Notice of Modification

The project approval for the Collector Wind Farm (10_0156), granted by the Planning Assessment Commission, as delegate of the Minister for Planning, on 2 December 2013.

End of modification
(SSD 10_0156 MOD 3)

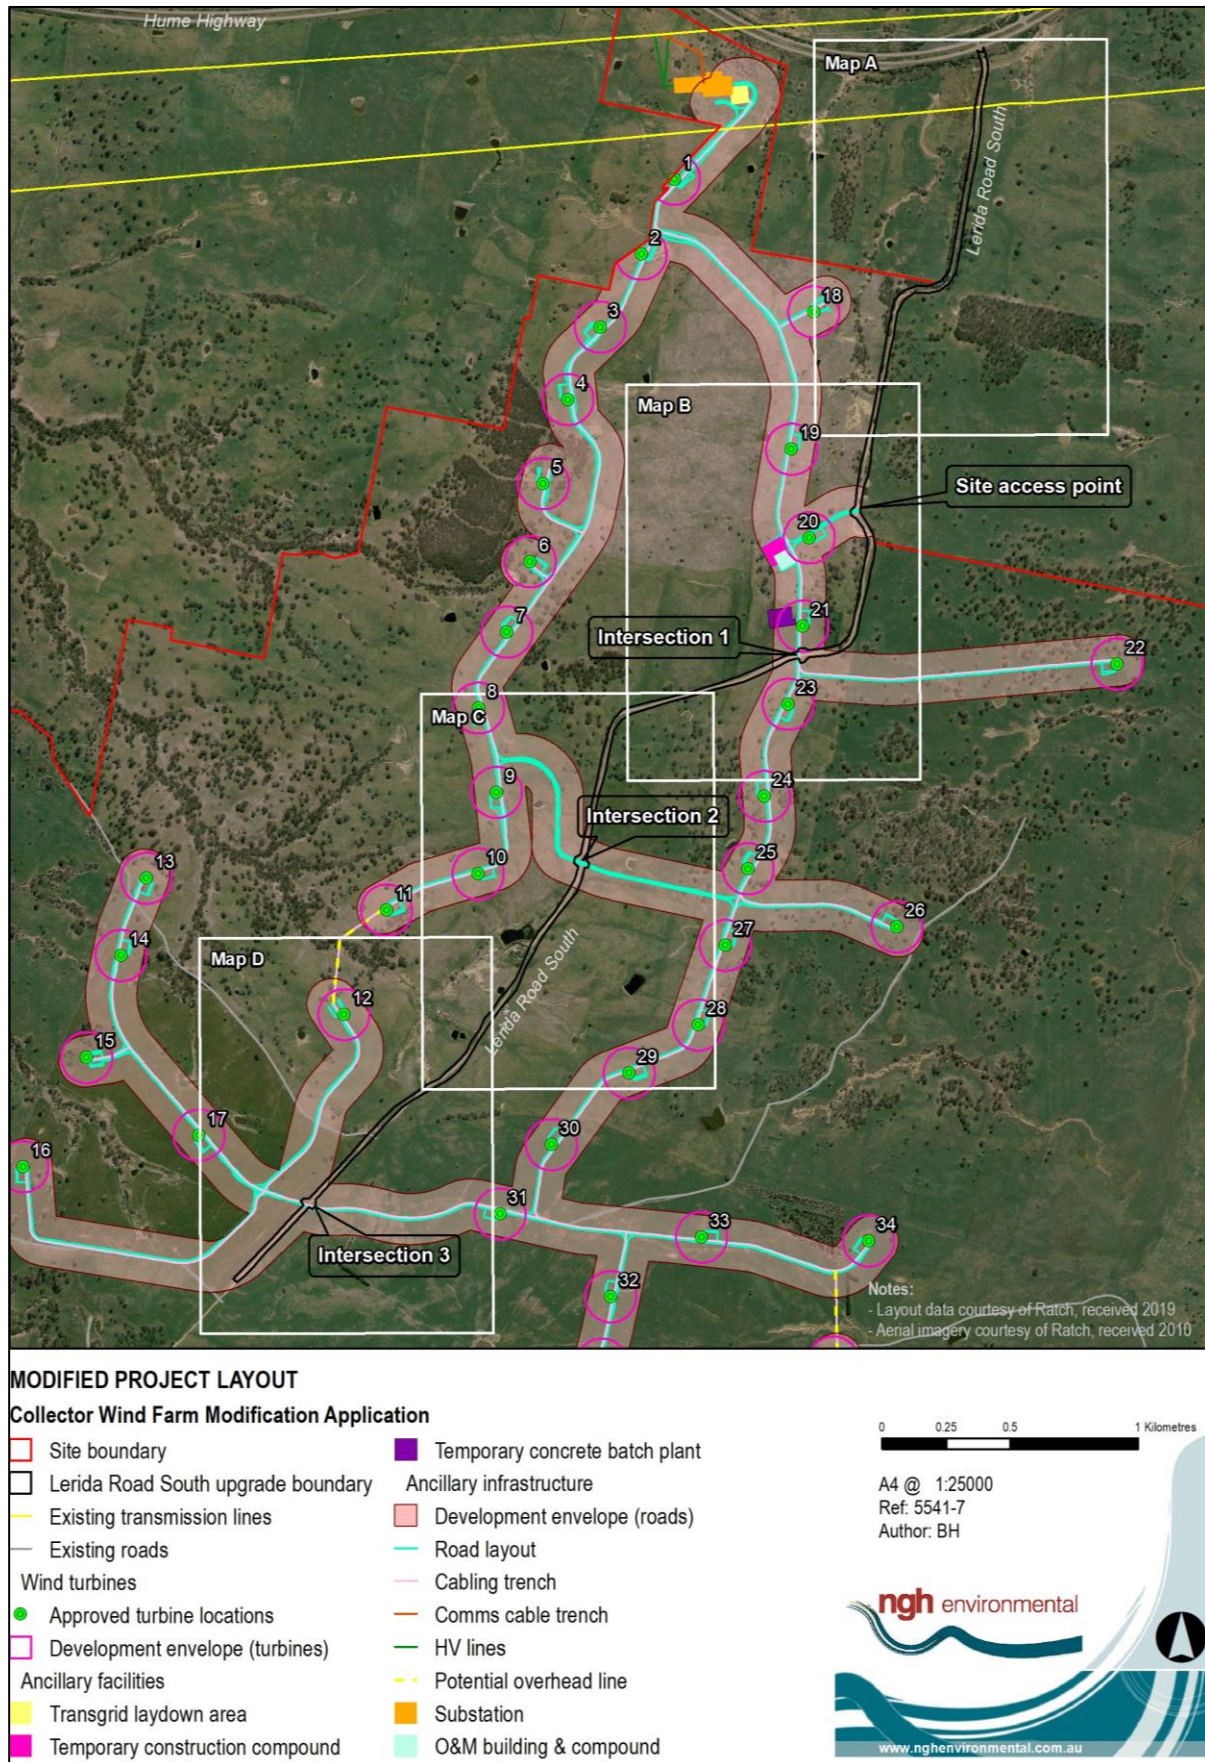
4. Delete the Project Layout figure in **ATTACHMENT 2** and replace with the following:

Map B

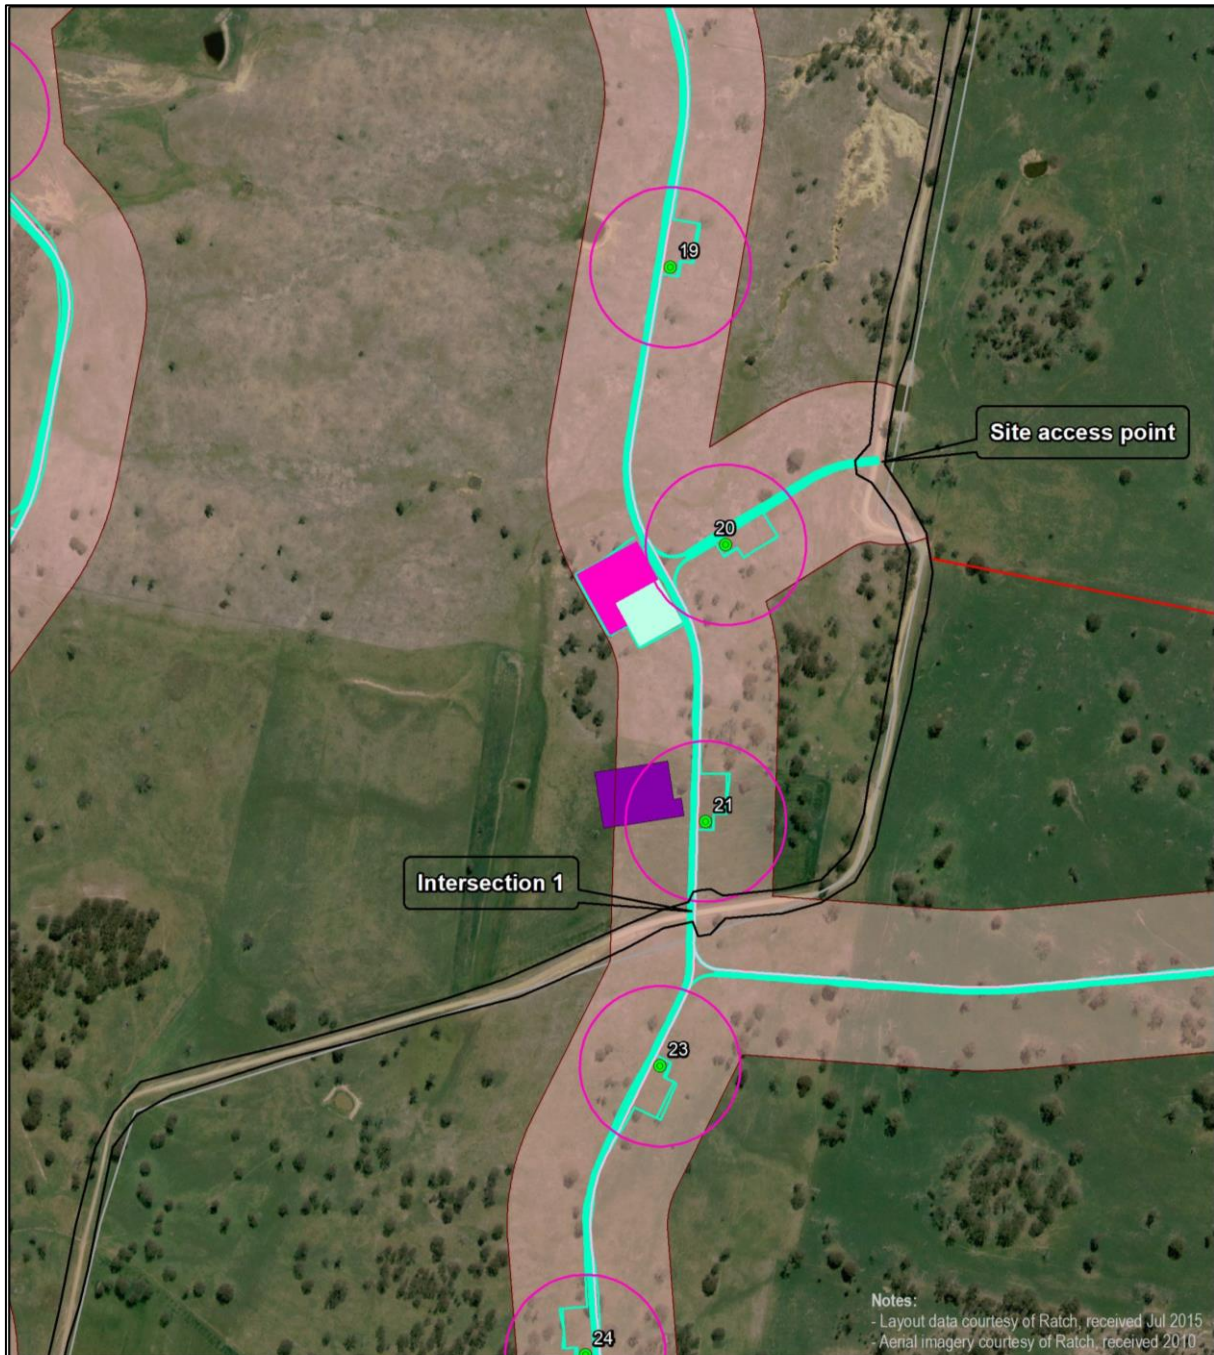
5. Delete the first and third figures in **ATTACHMENT 3** and replace with the following two figures:
